SALIDA SANITARY DISTRICT

ADDENDUM NO. 1

For The COVERT LIFT STATION UPGRADES - REBID

August 1, 2023

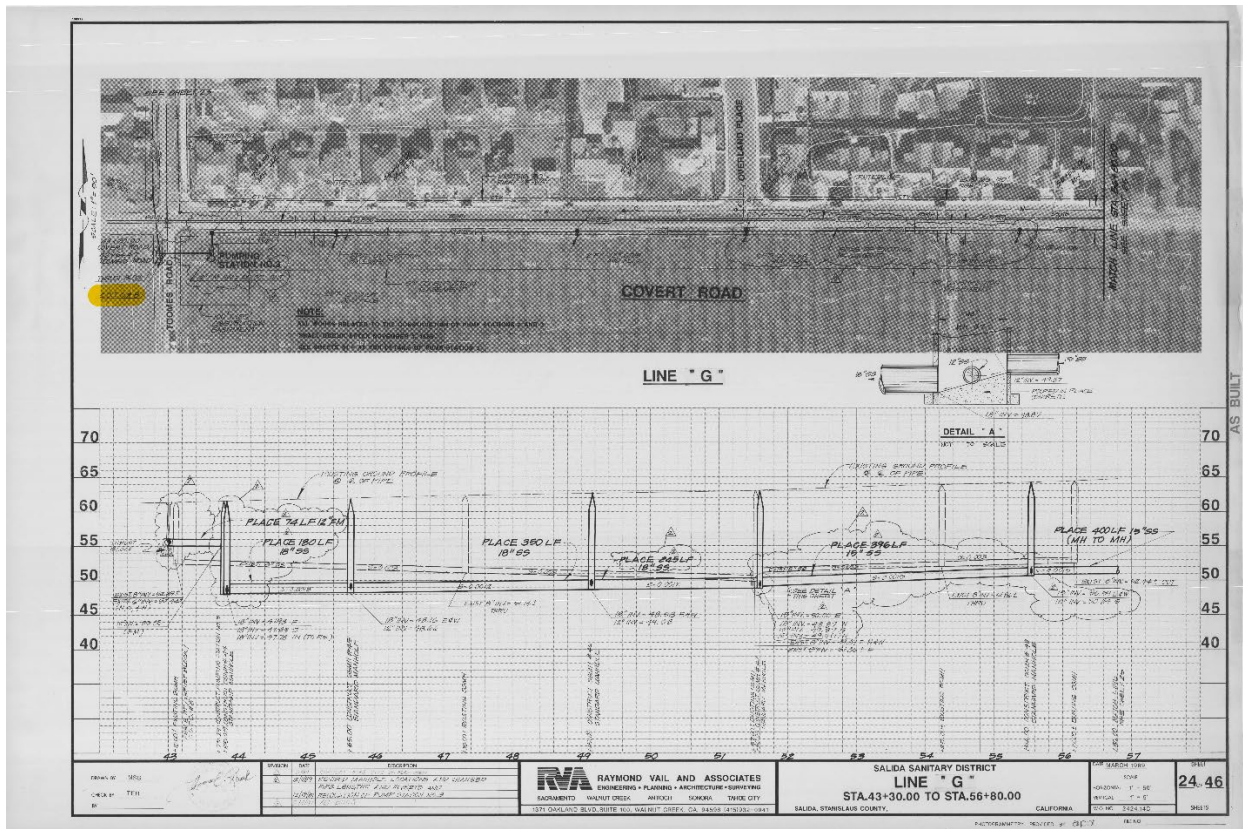
Question: On drawing C.05 detail 2. There is a note stating, "thickness as noted on the drawings". We do not see any note on other drawings regarding this thickness. Are we to assume this is to be 8"?

Response: Regarding the note "Thickness as indicated on the dwg's with 8" min." found on Detail 2 of Sheet C.05, the thickness for the Equipment Slab is only noted on Detail 2 of Sheet C.05. As specified in the note, the minimum thickness for the reinforced concrete section of the equipment slab is 8-inches.

Sheet 24 from original 1991 Covert Lift Station drawings.

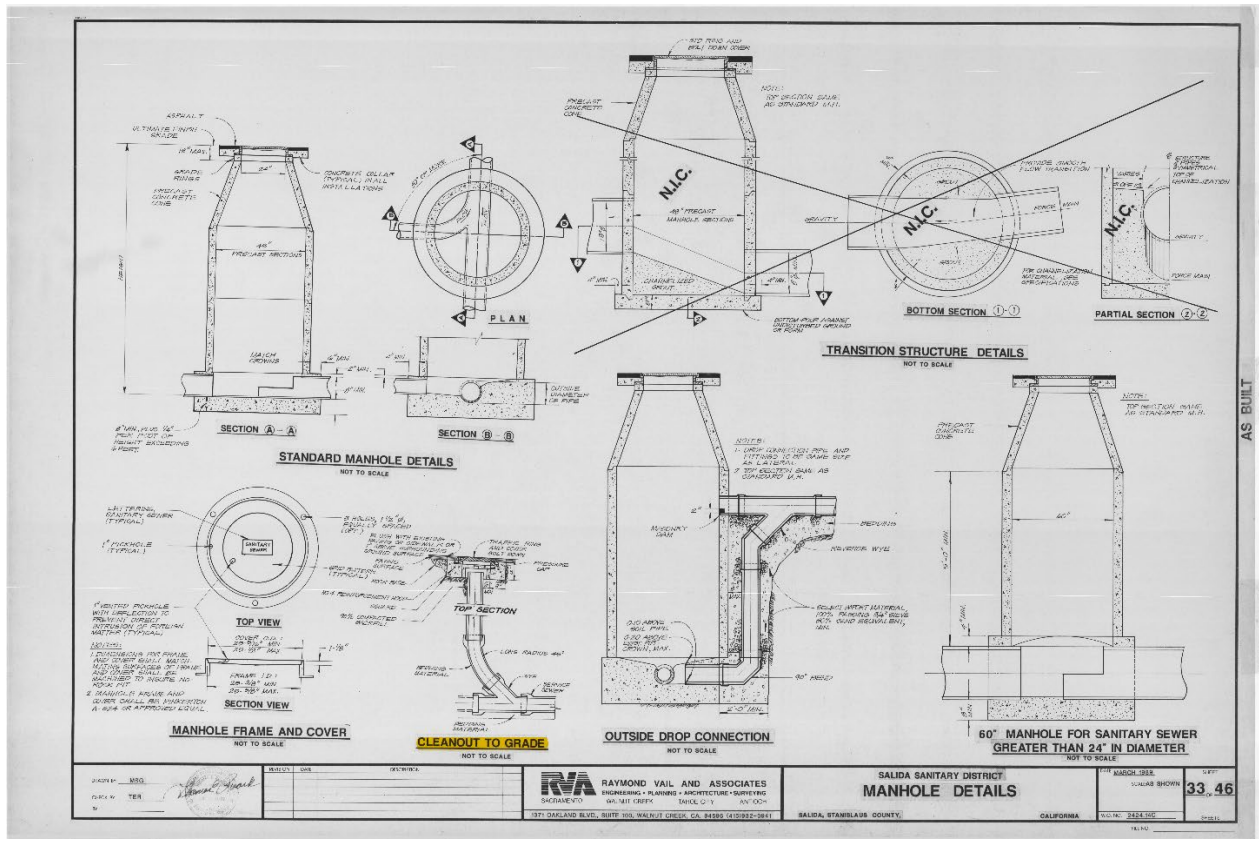
Question: In the sewer bypass pumping specification 01510, section 1.1 scope of work directs the contractor to discharge the sewer bypass into manhole #75, as part of a separate gravity system. Instead of manhole #75, may the contractor consider the option to discharge the sewer bypass into the manhole located across Toomes Rd. (the one that the Covert L.S. discharges into)?

In regards to discharging into the facility on Toomes Road (south of the intersection with Covert Road), the facility is a cleanout with a bolt down cover that connects to the 12" forcemain (refer to Sheet 24 and Cleanout Detail from the original 1991 Covert Lift Station drawings below). Please note that the District has never used this cleanout and is unaware of the feasibility of utilizing the cleanout as a bypass.
